CHRYSLER A604 (41TE) UPDATE HANDBOOK

INDEX

*Updated
May, 2003*

Figure 38

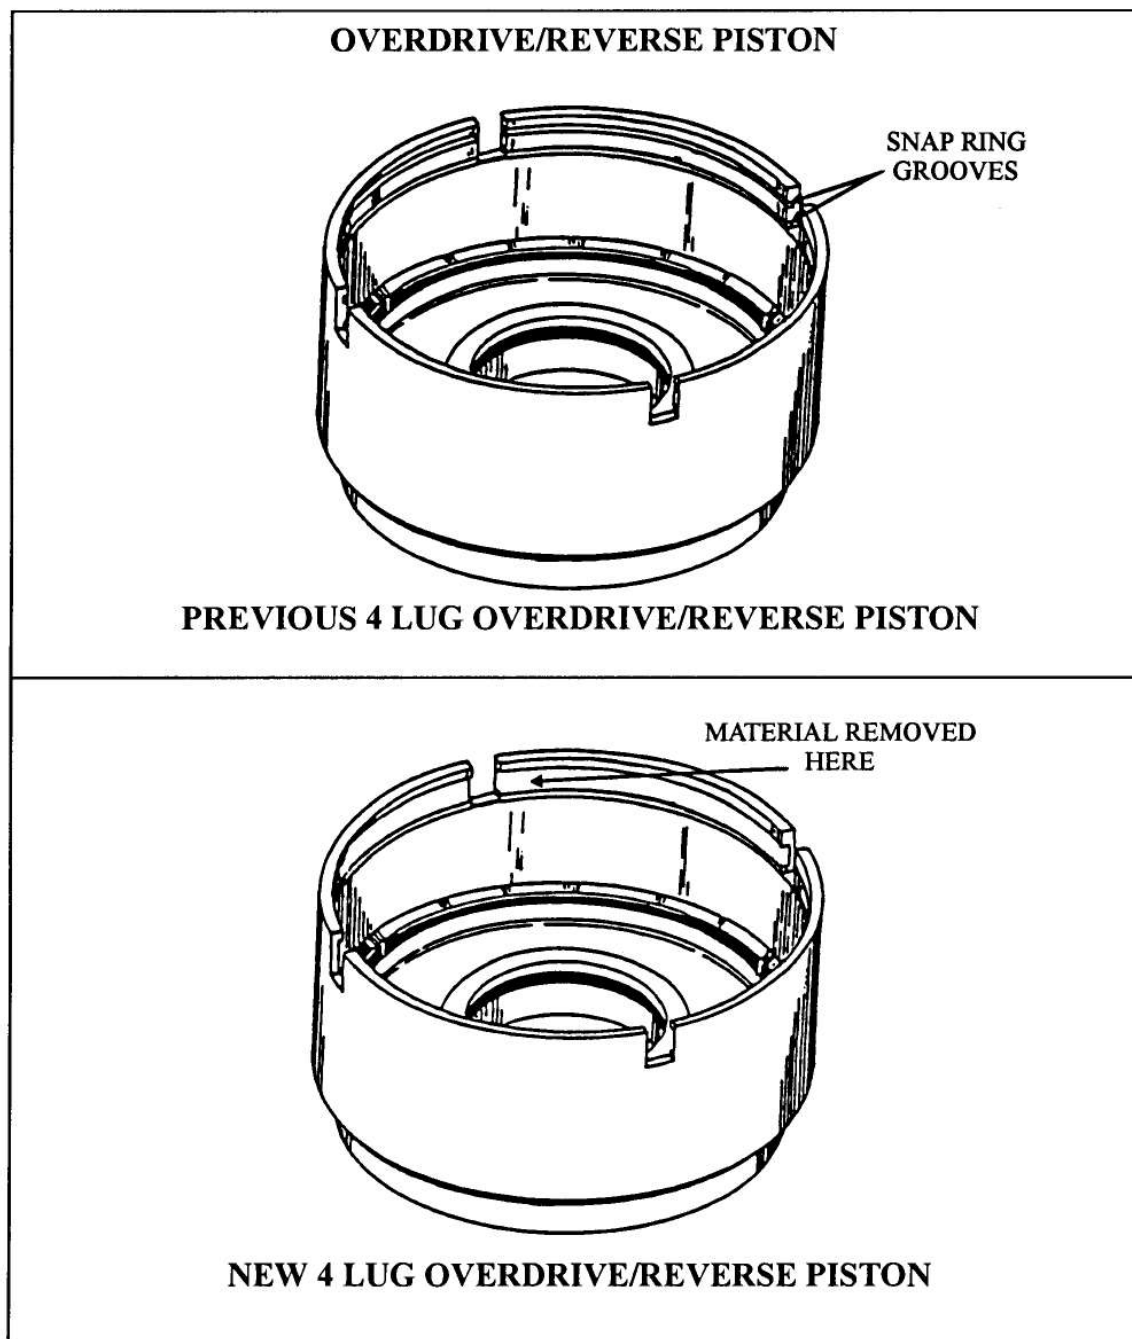
CHANGE: A 1991 running change was made to the overdrive/reverse piston, eliminating the material between the two snap ring grooves (See Figure 38).

REASON: To prevent the possibility of the overdrive/reverse reaction plate from binding in the overdrive/reverse drum, since it is also piloted on the outside diameter (See Figure 38).

- (1) **OVERDRIVE/REVERSE PISTON** - The drum material between the previous two snap ring grooves has been eliminated, as the Overdrive/Reverse Reaction Plate is also piloted on the outside diameter (See Figure 38). The snap ring and plate "Stack-Up" is **EXACTLY** the same as previous models with the new design level piston.

Overdrive/Reverse Piston (New Design).....4566310

Figure 39

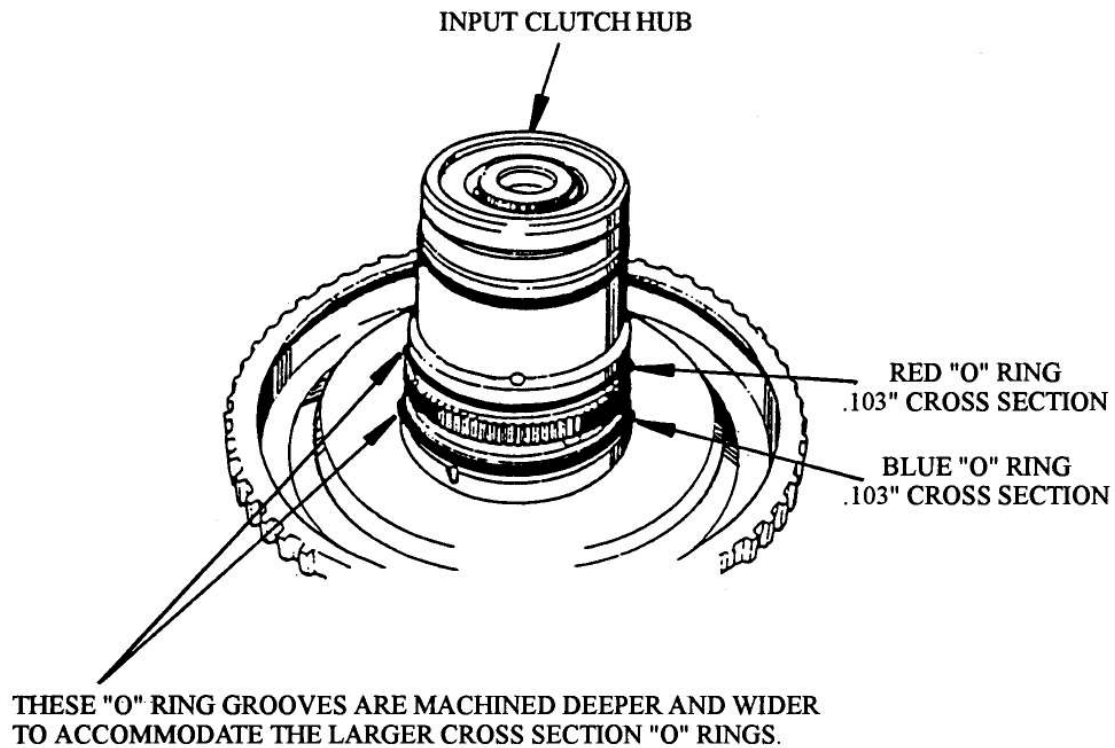
- (1) **INPUT CLUTCH HUB** - The "O" ring grooves on the Input Clutch Hub are cut deeper and wider to accommodate the larger cross section color coded "O" rings (See Figure 39).

Figure 42

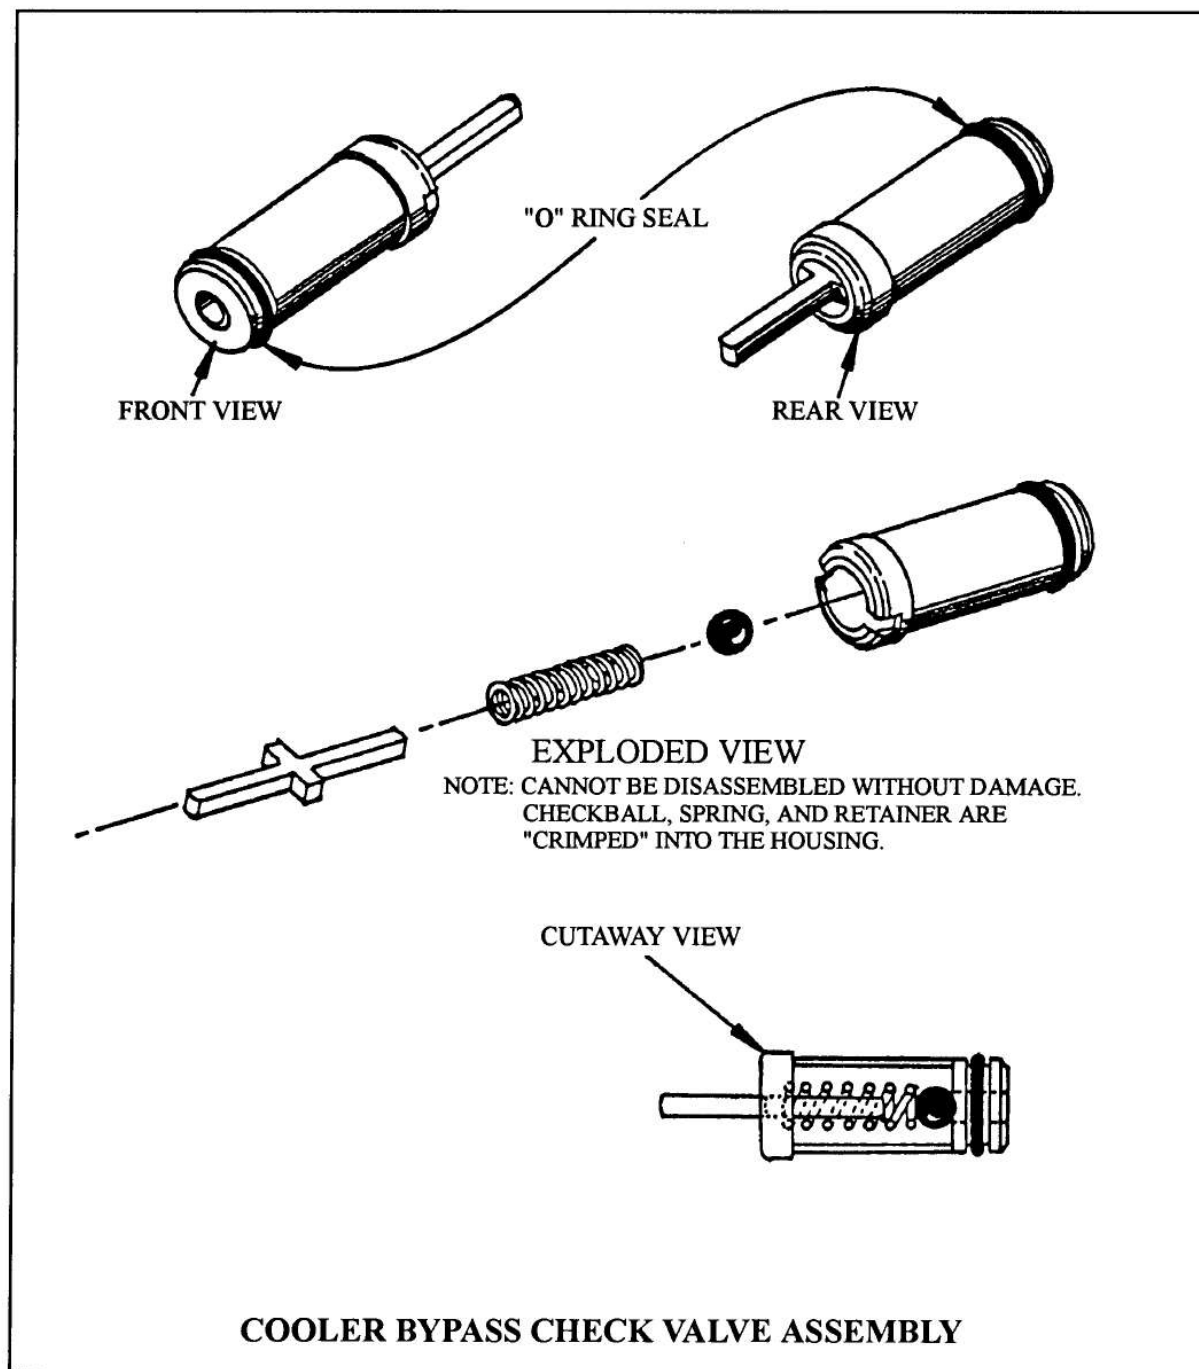
CHANGE: Beginning in 1991 model A604 transaxles, there has been a "Cooler Bypass Check Valve Assembly" added in the transaxle case behind the oil pump. (See Figures 42 and 43).

Figure 43

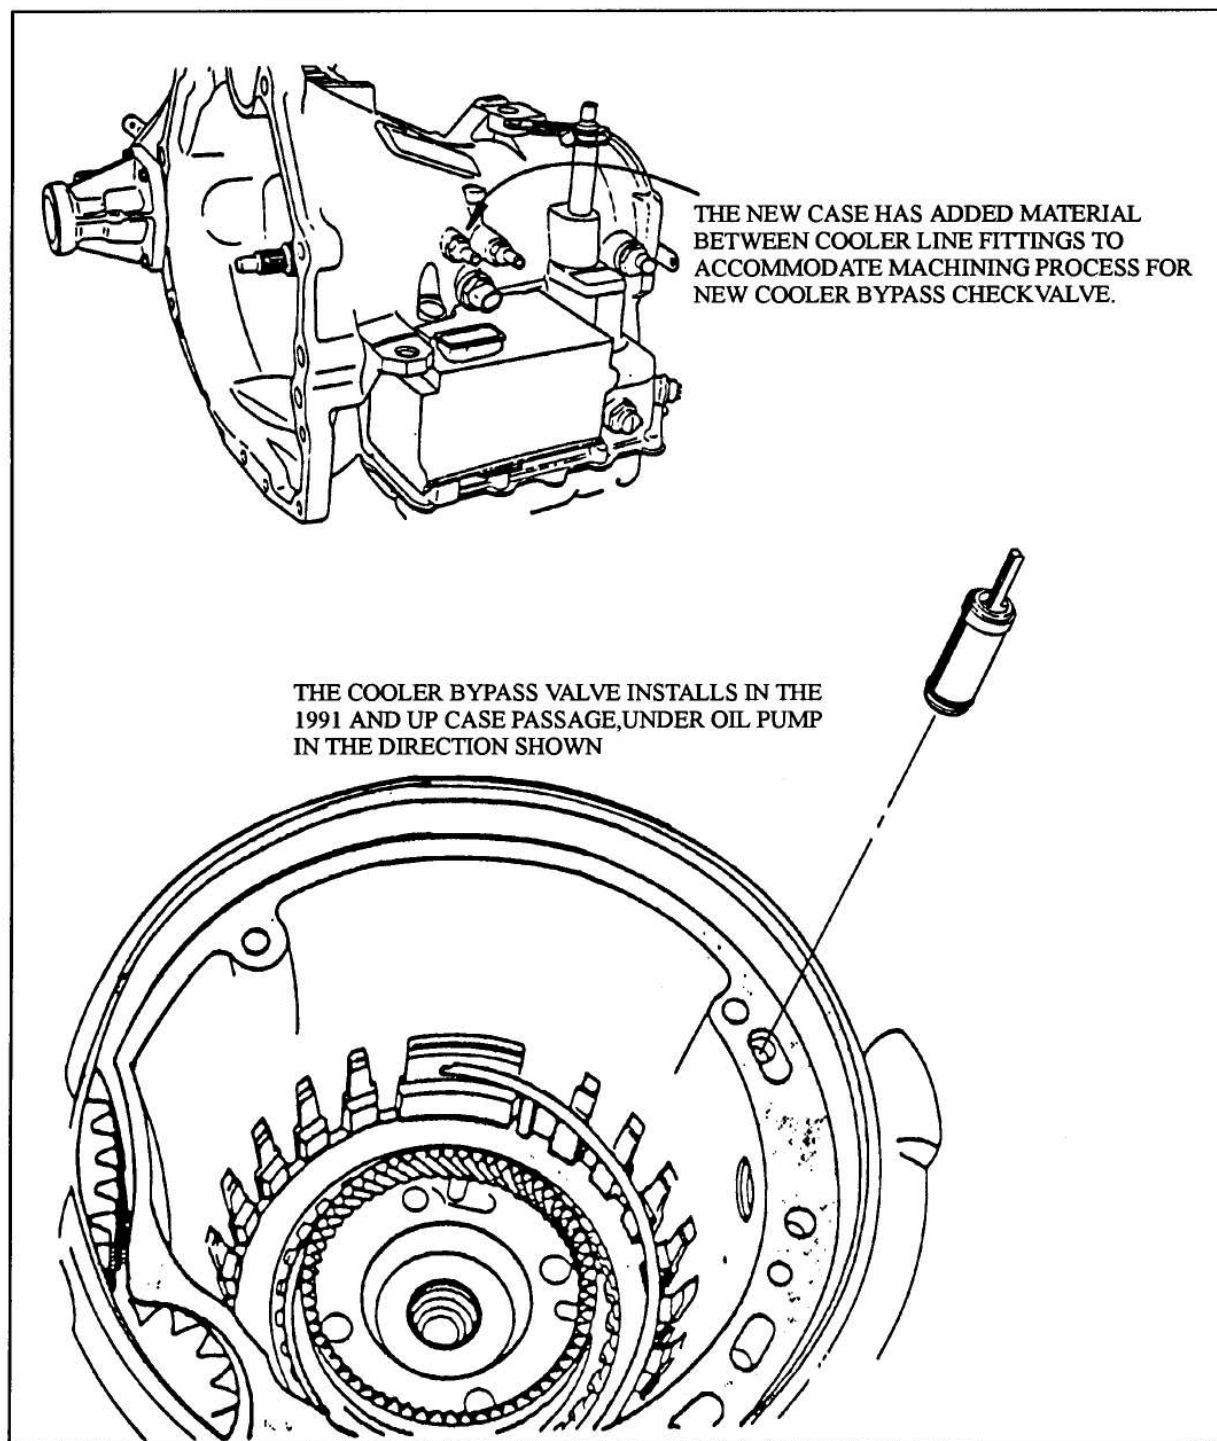
- (1) **COOLER BYPASS CHECK VALVE** - added into the case cooler passage behind the oil pump (See Figure 43). If cooler oil flow is restricted, or blocked, the new check valve will open, and allow cooler feed oil direct into the lube circuit to prevent transaxle damage. Normal operation is resumed after oil temperature is warm enough to again flow through the cooler. (See Figure 42).
NOTE: Customers should be advised to let the vehicle warm-up thoroughly before attempting to drive the vehicle, especially in the colder climates.
- (2) **TRANSAXLE CASE** - The new case has added material between the two cooler line fittings, to accommodate the machining process needed for the new cooler bypass check valve assembly (See Figure 43).
- (3) **VALVE BODY SPACER PLATE** - Lube feed hole in spacer plate has been enlarged to .112", as shown in Figure 44.

Cooler bypass check valve assembly "WILL NOT" retrofit back to previous models, unless the new transaxle case is installed at the same time. The lube feed hole in the spacer plate can be drilled to .112" on all models to improve lube oil flow (See Figure 44).

Figure 44

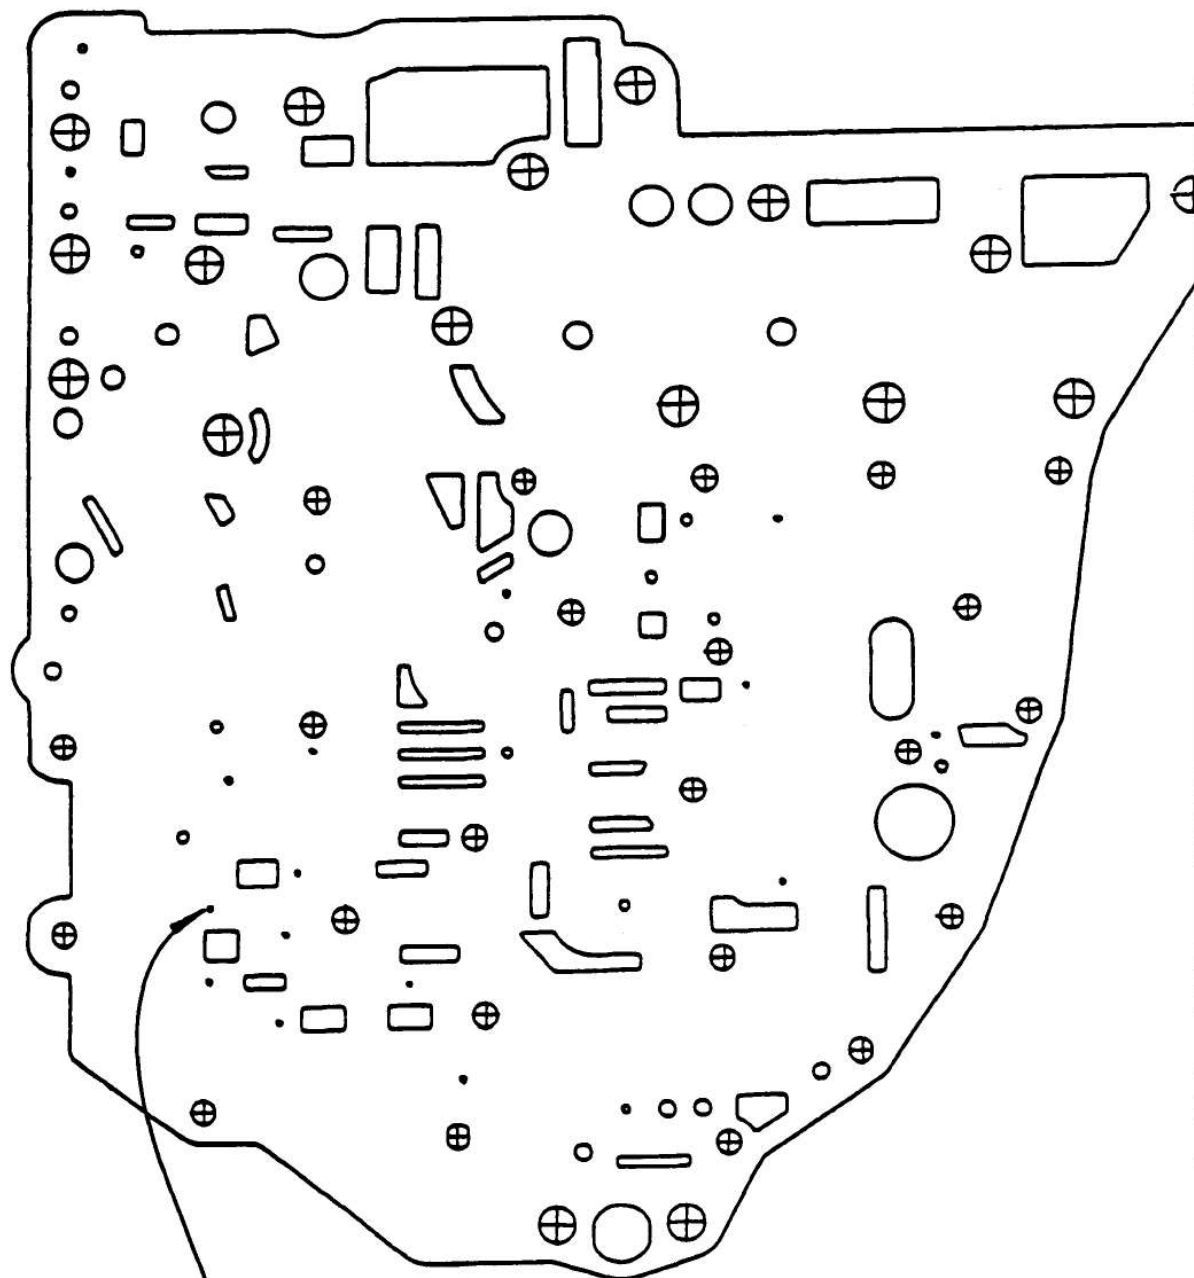
ENLARGE THE HOLE INDICTAED BY
THE ARROW ABOVE TO .112" ON ALL
MODELS TO IMPROVE LUBE OIL FLOW

Figure 60

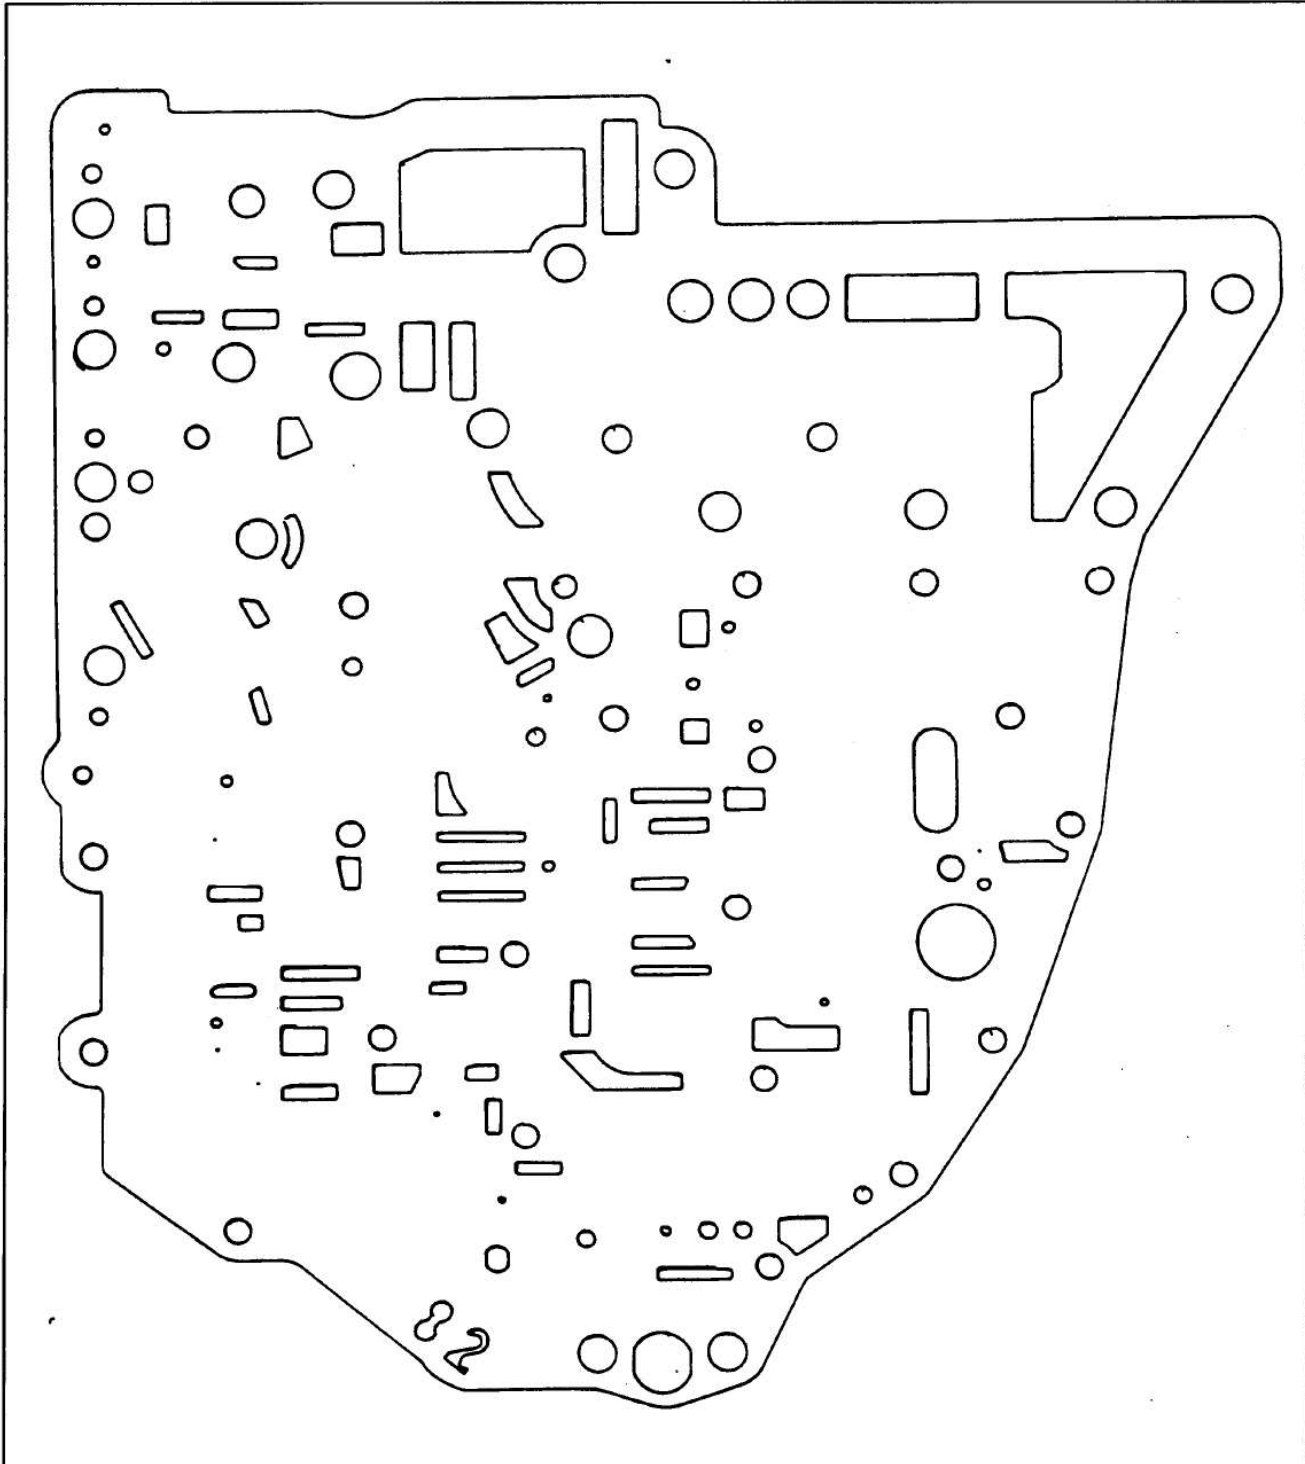
CHANGE : A running change in 1994 was made to the spacer plate (See Figure 60) and to the Pressure Regulator Valve (See Figure 61).

The new "82" spacer plate replaces the previous "96" spacer plate and can retrofit back to all valve bodies and Transfer Plates that use the # 96 spacer plate **provided that the new pressure regulator valve is used together with the # 82 spacer plate.** Valve bodies that use a 96 spacer plate has a casting number of 4511644 (See Figure 52 on Page 68). Transfer Plates that use the # 96 spacer plate has a casting number of 4511645 (See Figure 54 on Page 70).
